File 1994-0167

Name: Ridge Point Subdivision – Preliminary – North o Bella Pago – East of the Ridges

FILE # 167-94 TITLE HEADING: Final Plan/Plat - Ridge Point Sub.

FILE: #167-94
DATE: October 20, 1994
STAFF: Kathy Portner
REQUEST: Final Plat for Ridge Point
LOCATION: North of Bella Pago, East of High Ridge Drive
APPLICANT: Ted Munkres, Freestyle

RIDGE POINT - FILING 1
LOCATED IN NE 1/4 NW 1/4 Sec 21
T.1S. R.1W. U.M.

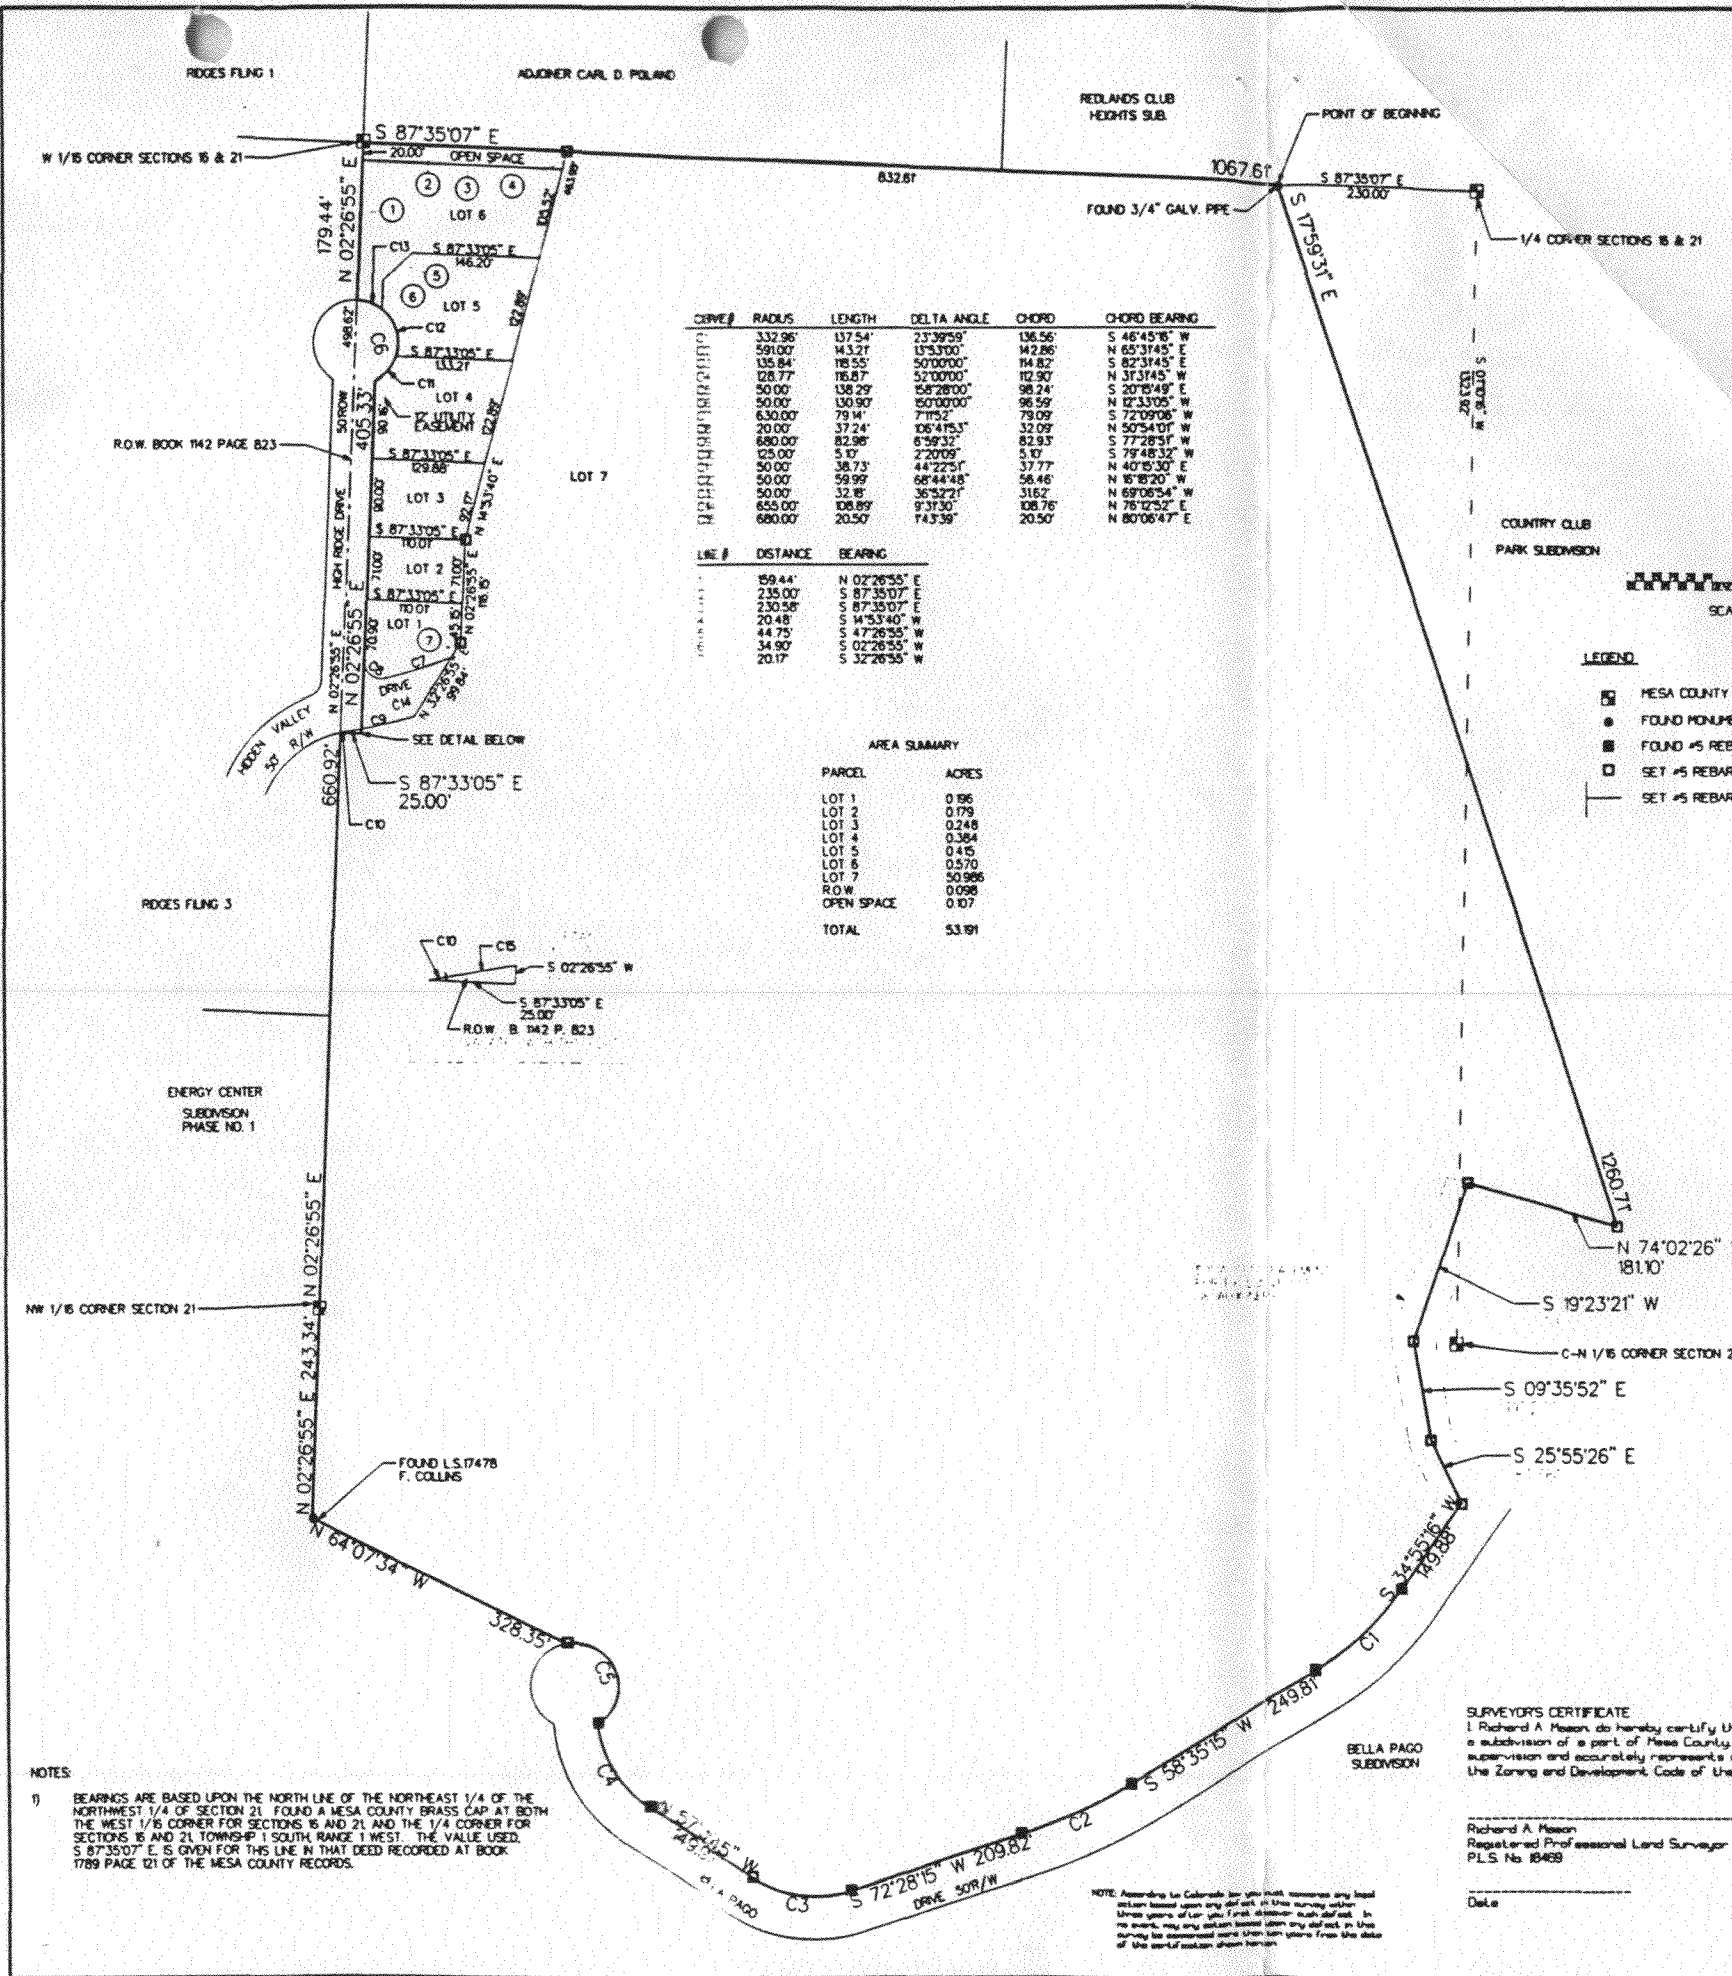
The location of the proposed new hydrant should be moved to the property line between lots 3 and 4. The water main is required to be a minimum of 6" if less than 250' long and it is served by a looped line at least 6" in size. If the line is served by a dead end main, the minimum size must be 8" and the total length of dead end line cannot exceed 1000'. The minimum fire flow required is 500 GPM. Petitioner must provide documentation that this minimum fire flow is provided.

Staff recommends denial of the plat for 6 lots because they are not in compliance with the general development standards of the Ridges amended plan. Staff would support a plat which eliminated lot 4.

4. What is the purpose of the 20' open space strip and what does it connect to?
5. The Ridges ACC must have an opportunity to review the proposed subdivision. Please submit for their review and request comments to be sent to the City Community Development Department prior to the Planning Commission hearing.

Additional fire hydrant, sewer and water service lines are a part of the utility composite and are planned to be installed.
